ADDENDUM NO. 1

PROJECT NAME: Textile Design Studio Renovation
UNL PROJECT NUMBER: A075P003

DATE OF ISSUANCE: January 16, 2013

FUME HOOD SECTION ALTERNATE 1

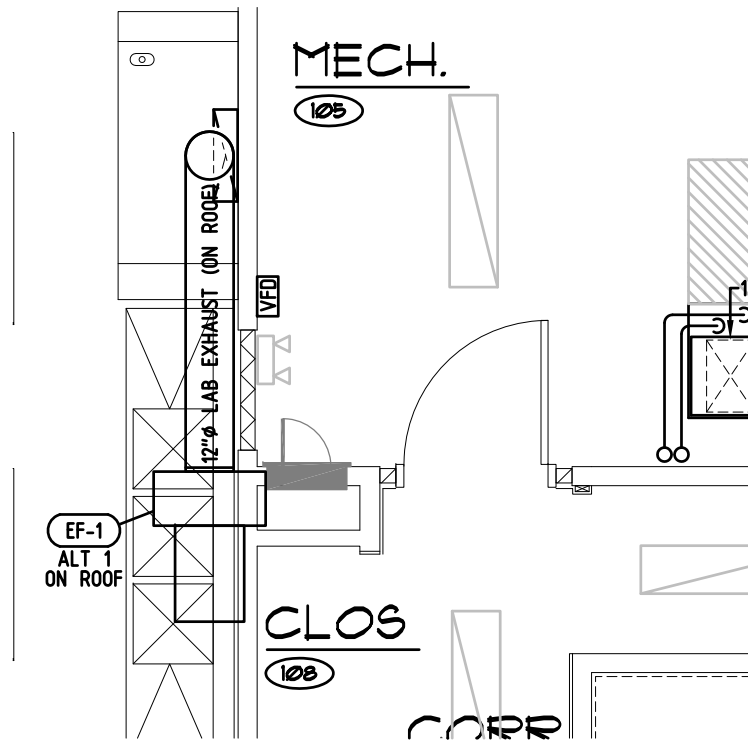
3. Fume Hood exhaust fan EF-1 (Alternate 1 – replaces EF-1 in base bid) shall be revised as follows: In lieu of the specified Greenheck Vector exhaust system, add the following specifications:

- PlasticAir Model C12P
 - 1200 cfm @1.25" esp
 - 3/4hp, 208v-3ph blower motor - VFD duty
 - Backward incline polypropylene wheel (fiberglass optional)
 - Fan shall be curb mounted with self supporting discharge stack

- Fiberglass clamshell housing with outlet stack reinforcement
 - Drain fitting
 - Self-supporting fiberglass discharge stack with velocity cone (extended to 10 ft. above roof)

- Weather hood
 - Fan rails
 - Fan shall be provided with weatherproof safety disconnect (installed by Electrical Contractor)
 - This design will be variable volume and will not include a bypass air inlet. The horizontal inlet duct to the exhaust fan shall be minimum 6 duct diameters straight run to allow installation of flow measuring apparatus by UNL-BSM. A round single blade isolation damper similar to United Enertech Model RI stainless steel option shall be provided and installed (by contractor) either between the roof jack and elbow or between the fume hood and roof structure. The control actuator will be provided and installed by UNL-BSM (coordinate as required). All fume exhaust duct, connections, and fittings between the fume hood and exhaust fan shall be sealed weather-tight and shall be manufactured of 304 or 316 stainless steel. All curb, duct, electrical, and control construction shall be appropriately flashed to meet UNL standards. The curb mounting, exhaust fan mounting, and stack shall be designed to sustain wind loading per IBC. A variable frequency drive with disconnect will be provided by UNL-BSM and installed by the electrical contractor in a location within the building mechanical room approved by the owner. A weatherproof safety disconnect will be installed at the exhaust fan on the roof by the electrical contractor. See attached drawing (M2.1) for fan location/orientation and fan detail.

- Under Fume Hood Fan Alternate 1, 'Exhaust Fan Schedule Notes', notes 1 through 7 shall apply to the above fan revisions and delete note 8.
 - Under Fume Hood Fan Alternate 1, 'Exhaust Fan Schedule Notes', notes 3, add that both the fume hood and the duct penetration shall include pre-fabricated curbs for a flat roof. Fabricated curbs shall include an 18 ga (min.) galvanized metal coping cap.

ELECTRICAL RISER DIAGRAM

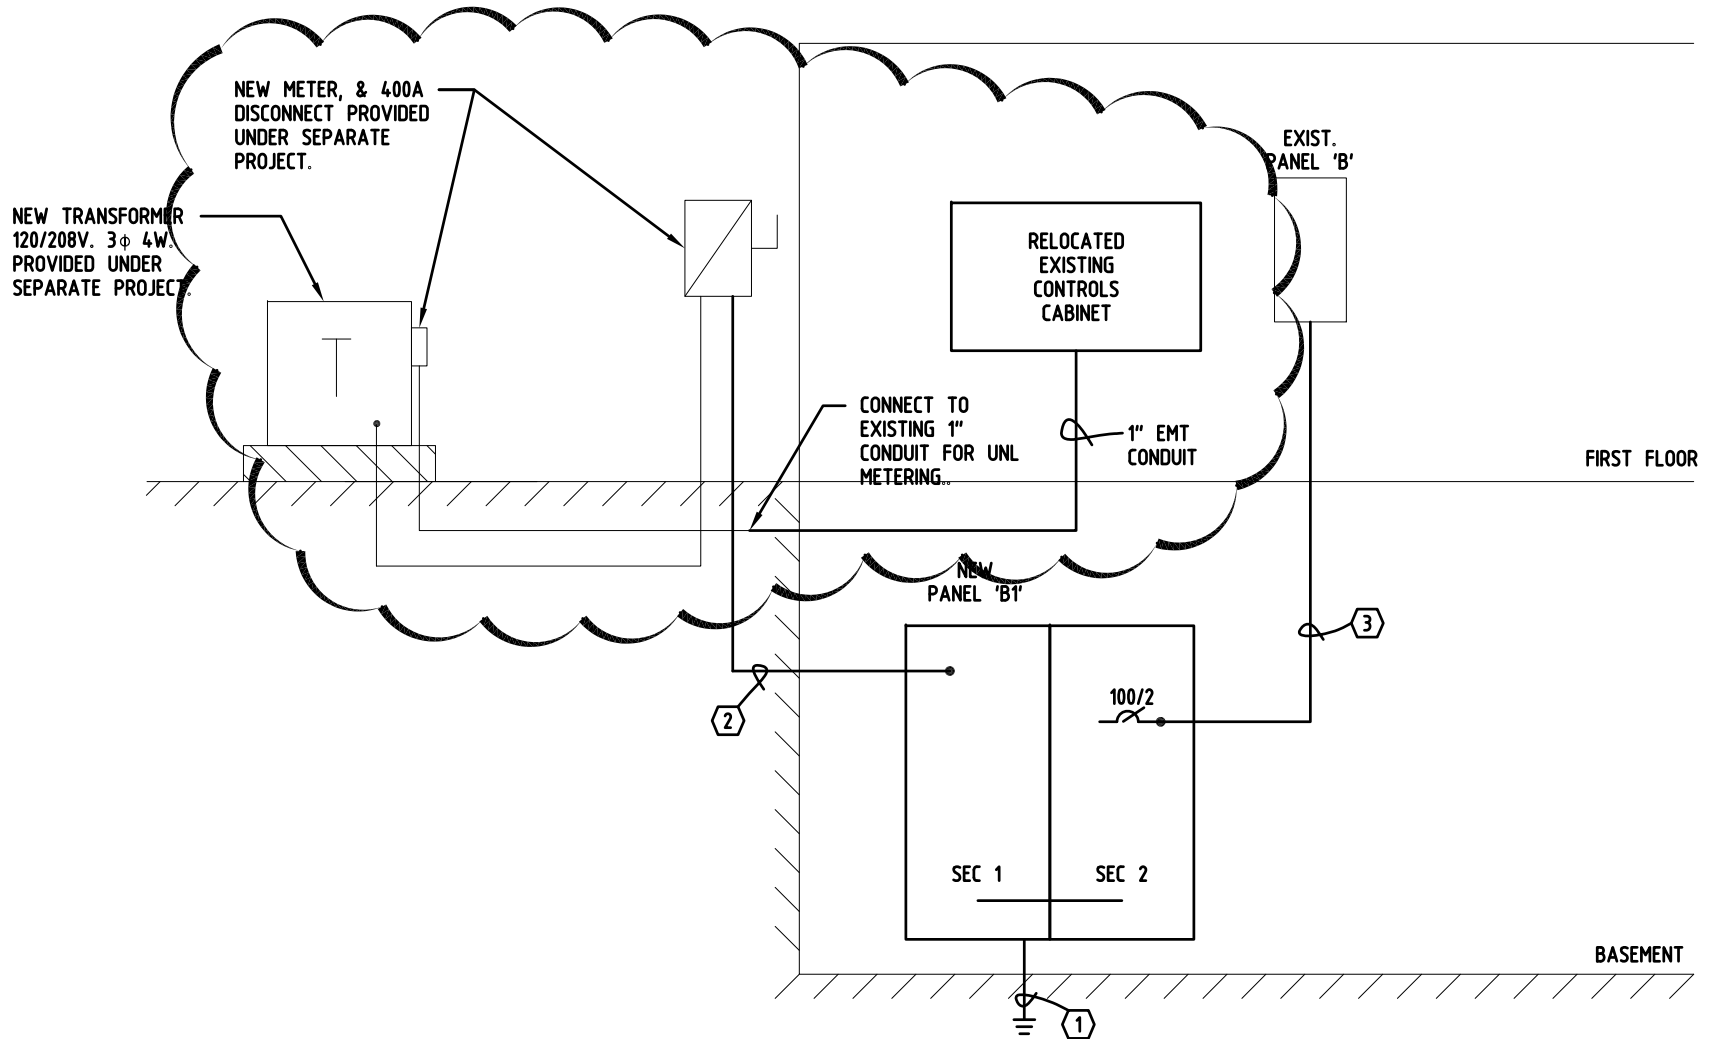
1. Contractor to provide and install a 1" EMT conduit from the Relocated Existing Controls Cabinet through basement and out of the building. Connect the new 1" conduit to existing 1" conduit provided under separate project. See attached drawing (E3.1) for additional information.
2. Equipment Connection Schedule – EF-1 fan size shall be 3/4hp in lieu of 1 1/2hp. Note 1 shall read as, "Disconnect provided with fan and VFD with disconnect will be provided by UNL BSM and installed by Elec. Contr."
